# Access Compliance Report

## Public Rights-of-Way

### (Curb Ramps)

Intersection ID: 19674	Main Street: BARCLAY_DOWNS_DR	Cross Street: MORRISON_BV	Location: SE
ADA ID: CA52A7C6B8FB	Ramp Type: Perp	Initial Pass/Fail: Fail	Overall Compliance: No
Severity Score: 25			
Codes/Mitigation Info/Possible Solution		Field Measurements/Component Compliance

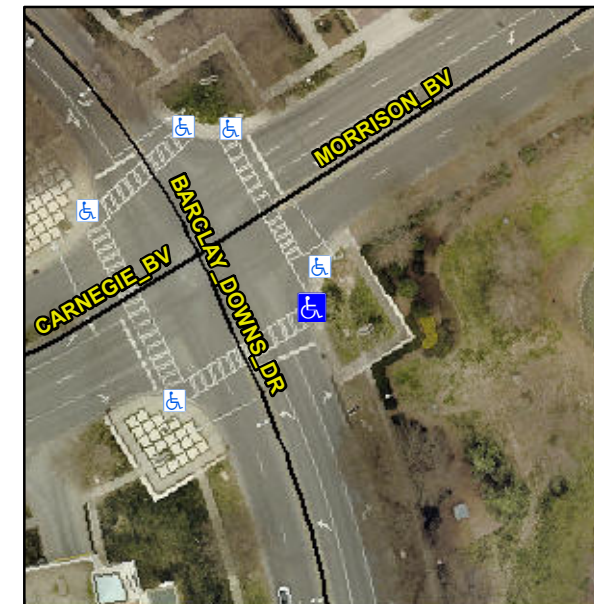
Compliance	Description	Data	Compliance	Description	Data
N/A	Ramp Length (in)	58.0	No	Ramp Slope (%)	12.4
Yes	Ramp Width (in)	48.0	Yes	Ramp XSlope (%)	1.4
N/A	Flare Type LT	N/A	N/A	Flare Type RT	N/A
N/A	Flare Slope LT (%)	N/A	N/A	Flare Slope RT (%)	N/A
N/A	Flare Traversable LT?	N/A	N/A	Flare Traversable RT?	N/A
N/A	Landing Length (in)	N/A	N/A	DWS Provided?	N/A
N/A	Landing Width (in)	N/A	N/A	DWS Contrast?	N/A
N/A	Landing Slope (%)	N/A	N/A	DWS Length (in)	N/A
N/A	Landing X Slope (%)	N/A	N/A	DWS Full Width?	N/A
N/A	Landing Curb? (Y/N)	N/A	N/A	DWS Offset (in)	N/A
N/A	Shared Landing?	N/A			
N/A	Gutter Ponding?	N/A	N/A	Gutter Slope (%)	N/A
N/A	Gutter Lip Ht (in)	N/A	N/A	Gutter X Slope (%)	N/A
N/A	Painted X Walk1?	Yes	N/A	Painted X Walk2?	N/A
	X Walk 1 Direction	To SW		X Walk 2 Direction	N/A
N/A	X Walk 1 Width (in)	118.0	N/A	X Walk 2 Width (in)	N/A
	X Walk 1 Slope (%)	1.5		X Walk 2 Slope (%)	N/A
	X Walk 1 X Slope (%)	1.3		X Walk 2 X Slope (%)	N/A

**Remove & Replace Entire Ramp.**

**R304.2.2**
